Access Compliance Report

Public Rights-of-Way

Intersection ID: 47137	Main Street: DARLINGTON_RD	Cross Street: FIELDSTONE_MANOR_DR	Location: S
ADA ID: 29F5DDB4D624	Ramp Type: PerpDiag	Initial Pass/Fail: Fail	Overall Compliance: No
			Severity Score: 21.25

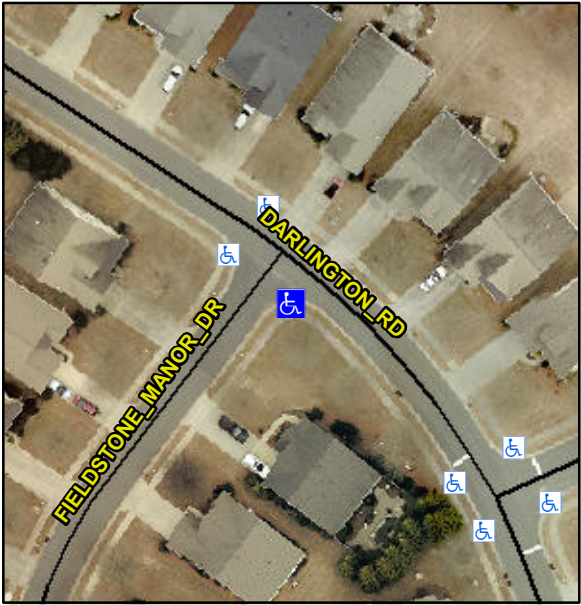
Codes/Mitigation Info/Possible Solution			Field Measurements/Component Compliance		
 <p>Street 1 Name DARLINGTON RD</p> <p>Stop Condition-Street 2 None</p> <p>Street 2 Name FIELDSTONE MANOR DR</p> <p>Stop Condition-Street 1 StopSign</p>	Possible Solutions:		Compliance	Description	Data
	Remove & Replace Curb Ramp With Two New Directional Ramps or Equivalent.		No	Ramp Length (in)	48.0
			No	Ramp Width (in)	40.0
			N/A	Flare Type LT	N/A
			N/A	Flare Slope LT (%)	N/A
			N/A	Flare Traversable LT?	N/A
			N/A	Landing Length (in)	N/A
			N/A	Landing Width (in)	N/A
			N/A	Landing Slope (%)	N/A
			N/A	Landing X Slope (%)	N/A
			N/A	Landing Curb? (Y/N)	N/A
			N/A	Shared Landing?	N/A
			N/A	Gutter Ponding?	N/A
			N/A	Gutter Lip Ht (in)	N/A
			No	Painted X Walk1?	No
				X Walk 1 Direction	To NE
			N/A	X Walk 1 Width (in)	N/A
				X Walk 1 Slope (%)	1.0
				X Walk 1 X Slope (%)	1.6
			N/A	Ramp inside XWalk1?	N/A
<p>Surveyor Notes:</p> <p>N/A</p> <p>PROW/ADA:</p> <p>Not Found, R304.5.1, R304.2.2</p>			N/A	Ramp inside XWalk2?	N/A
